Access Compliance Report Public Rights-of-Way (Curb Ramps)

Main Street: NEWPORT_BLV Cross Street: SKYLARK_PL Location: SE

ADA ID: RPRK220103115240 Ramp Type: Type 1 - Perpendicular Diagonal Initial Pass/Fail: Fail Overall Compliance: No Severity Score: 2

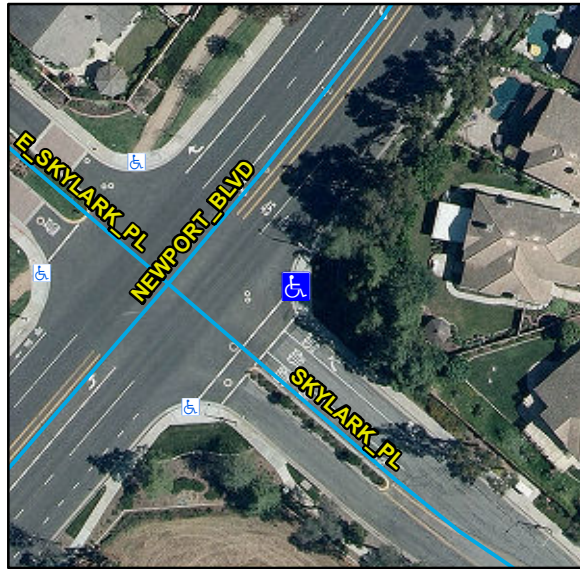
Compliance	Description	Data	Compliance	Description	Data
N/A	Ramp Length (in)	62	N/A	Flare Type LT	
Yes	Ramp Width (in)	48			N/A
Yes	Ramp Run Slope (%)	6.9	N/A	Flare Slope LT (%)	N/A
No	Ramp Cross Slope (%)	3.5	N/A	Flare Traversable LT	N/A
N/A	Landing Present	N/A	N/A	Flare Type RT	
N/A	Landing Length (in)	N/A			N/A
N/A	Landing Width (in)	N/A	N/A	Flare Slope RT (%)	N/A
N/A	Landing Run Slope (%)	N/A	N/A	Flare Traversable RT	N/A
N/A	Landing Cross Slope (%)	N/A	N/A	DWS Provided	N/A
N/A	Landing Movement Obstructed?	N/A	N/A	DWS Contrast	N/A
	Landing Movement Type	N/A	N/A	DWS Length (in)	N/A
N/A	Landing Shared	N/A	N/A	DWS Full Width	N/A
N/A	Clear Space	Yes	N/A	DWS Offset Left (in)	N/A
N/A	Clear Space To Crosswalk (in)	N/A	N/A	DWS Offset Right (in)	N/A
N/A	Marked Crosswalk 1	No	N/A	Marked Crosswalk 2	No
	Crossing 1 Direction	NW		Crossing 2 Direction	SW
	Marked Crosswalk 1 Width (in)	N/A		Marked Crosswalk 2 Width (in)	N/A

Remove & Replace Curb Ramp With Two New Directional Ramps or Equivalent.

R304.5.3, STD 1115
